Re: The Original Pancake House
5161 Journal Center
Traffic Circulation Layout
Engineer's Stamp Dated 9-20-24 (D18D061)

DRAINAGE AND TRANSPORTATION INFORMATION SHEET

The Original Pancake House
5161 Journal Center Blvd NE
Albuquerque, New Mexico

The Original Pancake House
5161 Journal Center Blvd NE
Albuquerque, New Mexico
Refuse
9/20/24

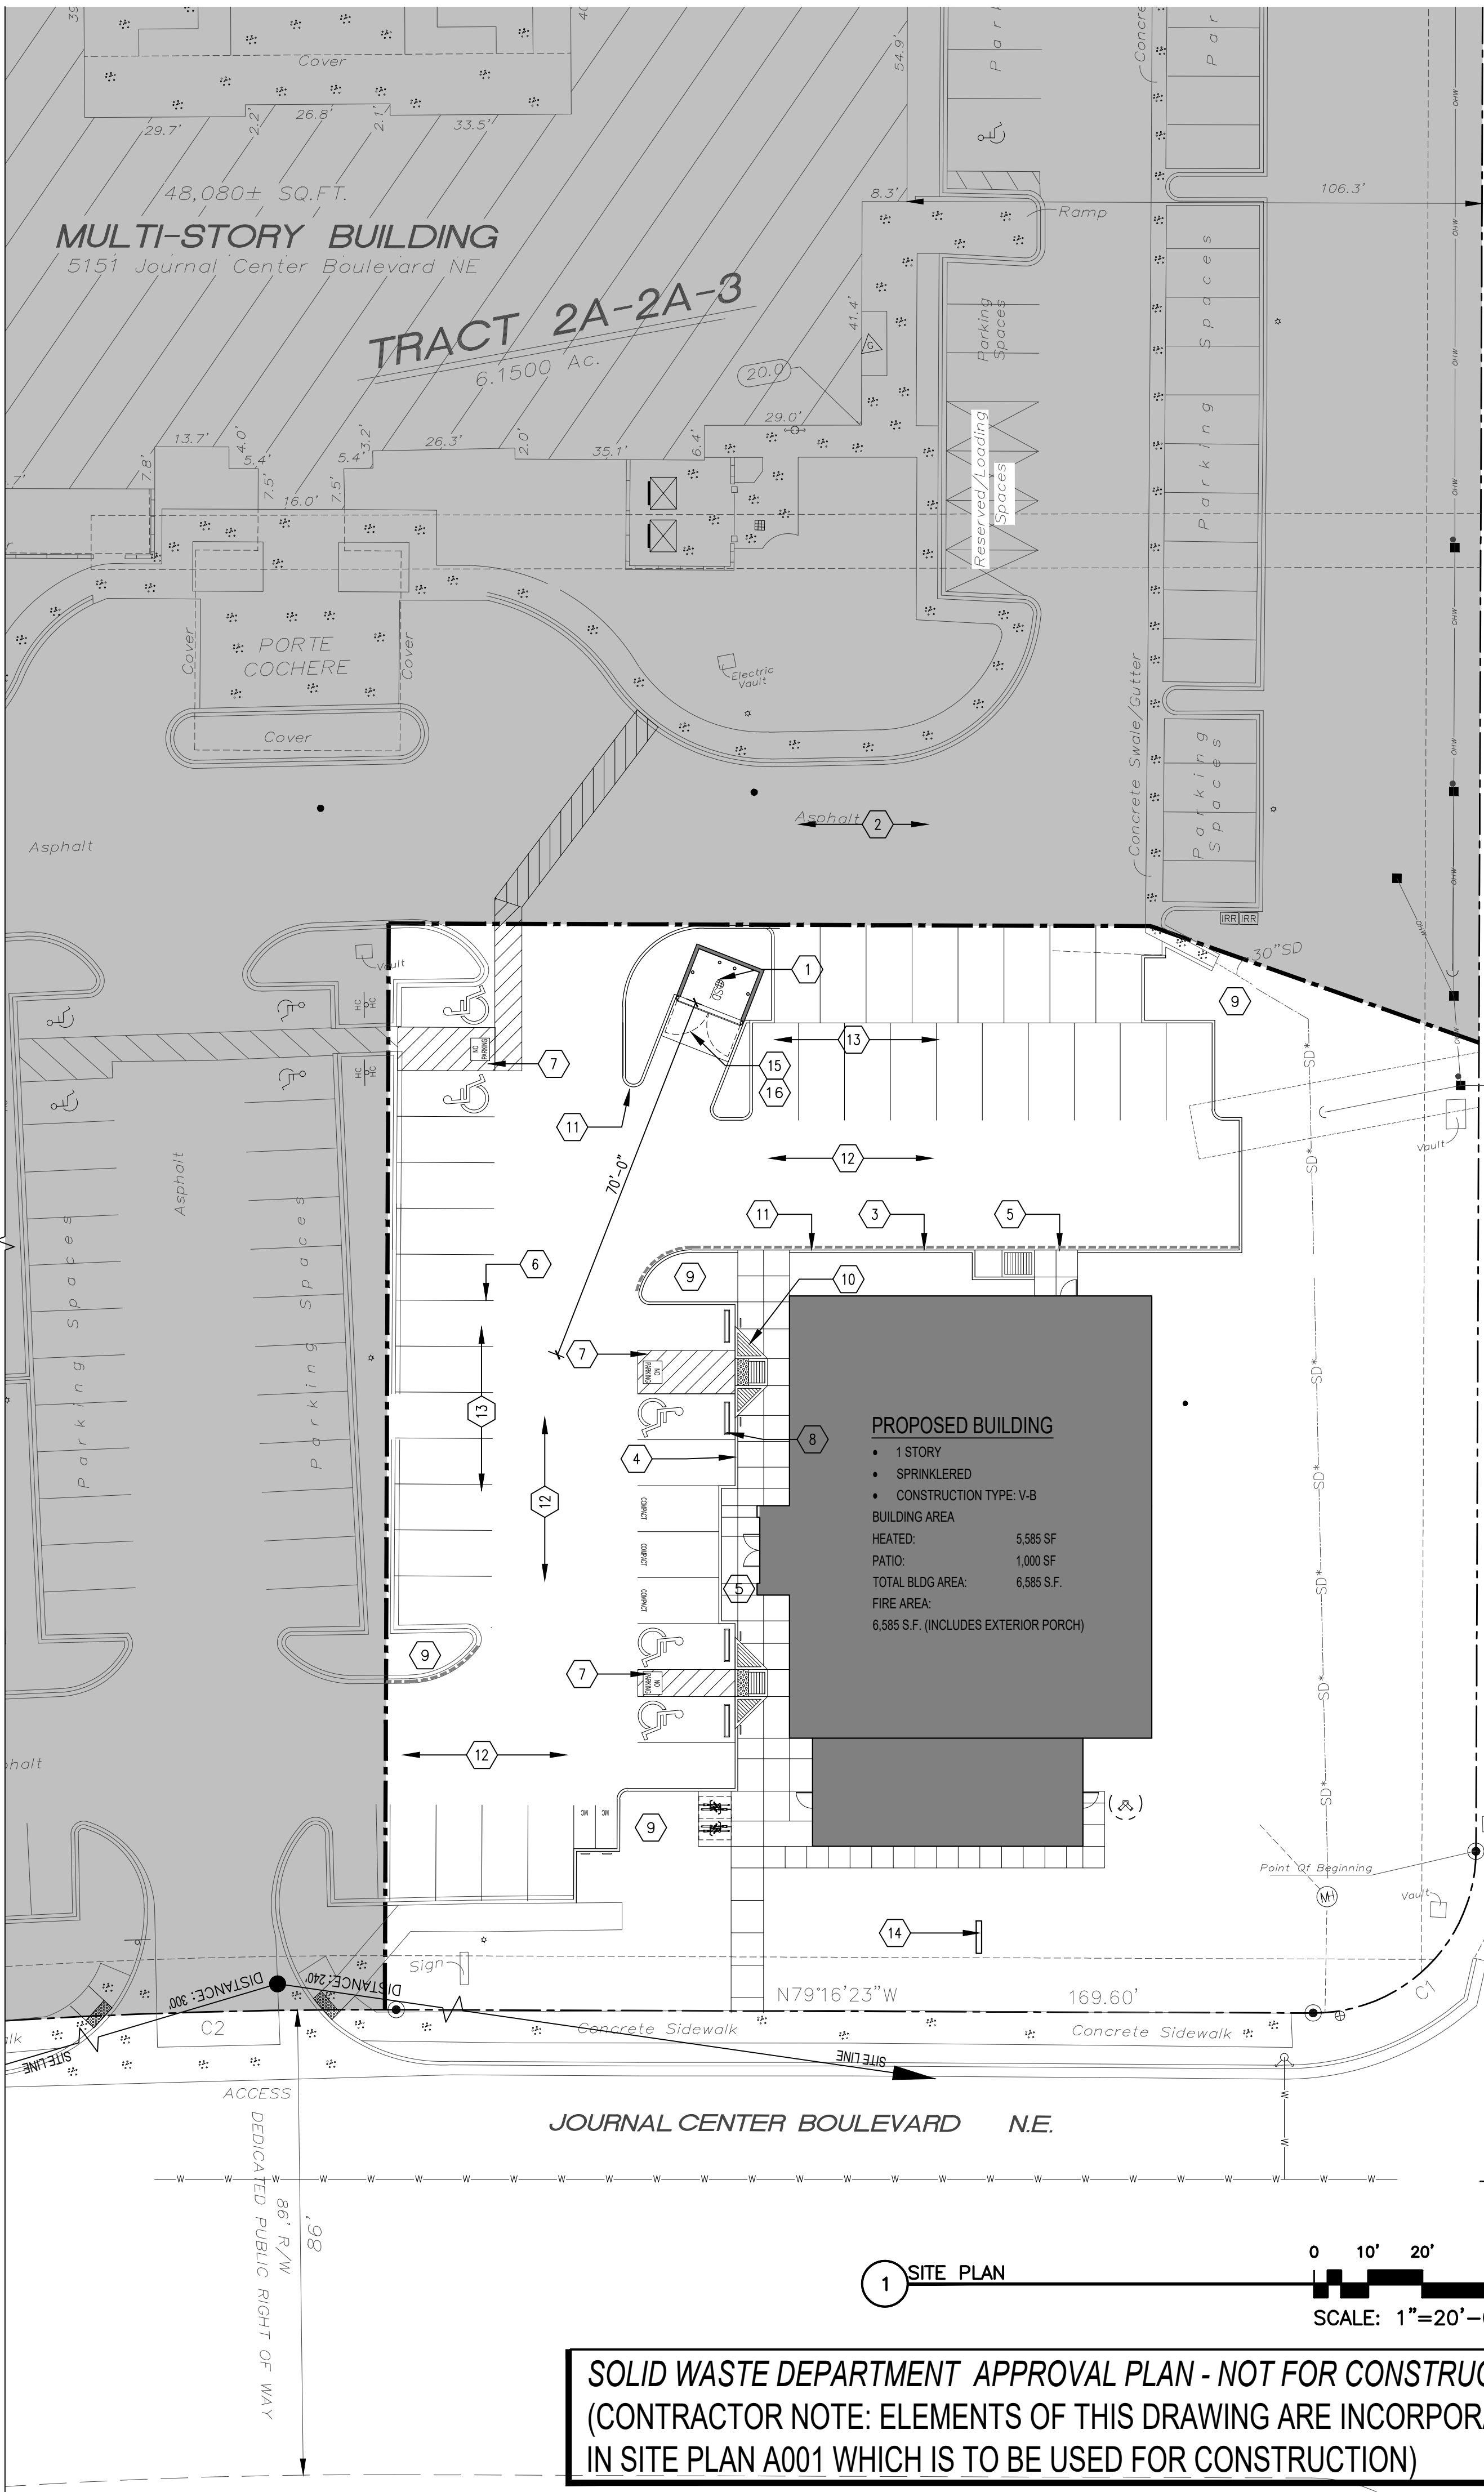
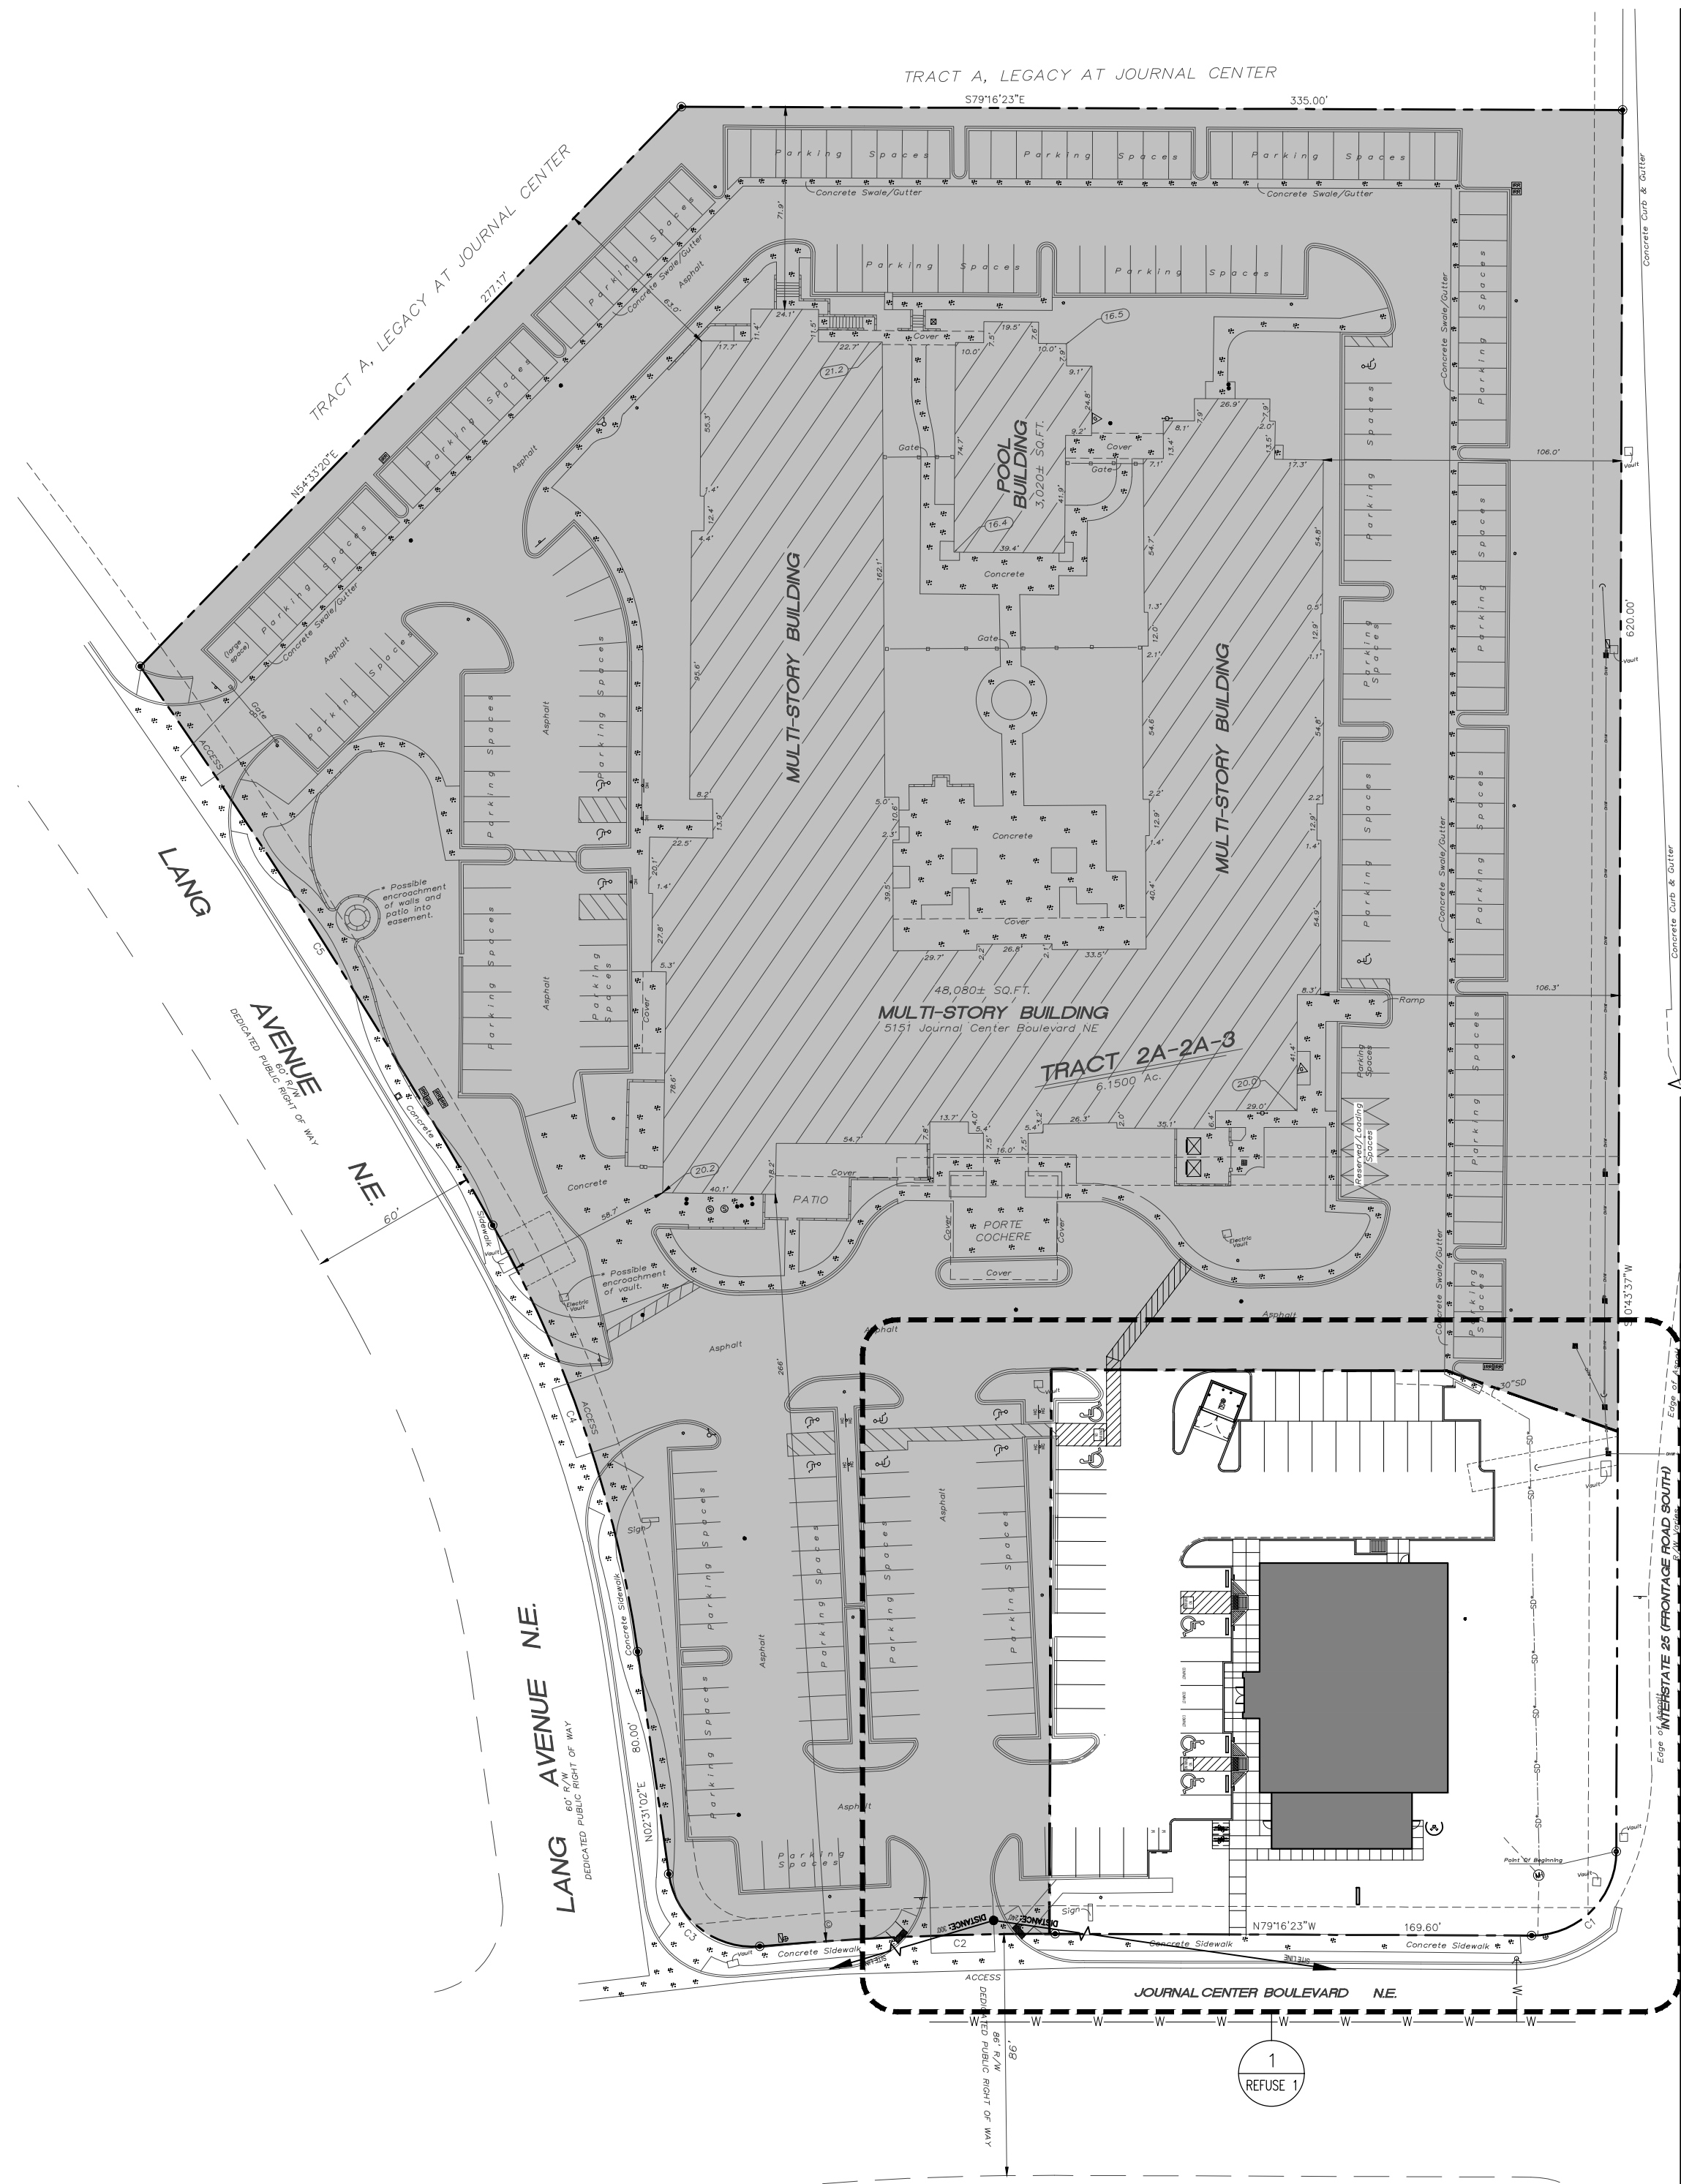
Approved for access by the Solid Waste Department.
All containers must be made accessible for pick up
between the hours of 5AM and 8PM.
Reviewer: Herman Gallegos
Date: 09-26-24
Hazard Route Only
Recycle service declined
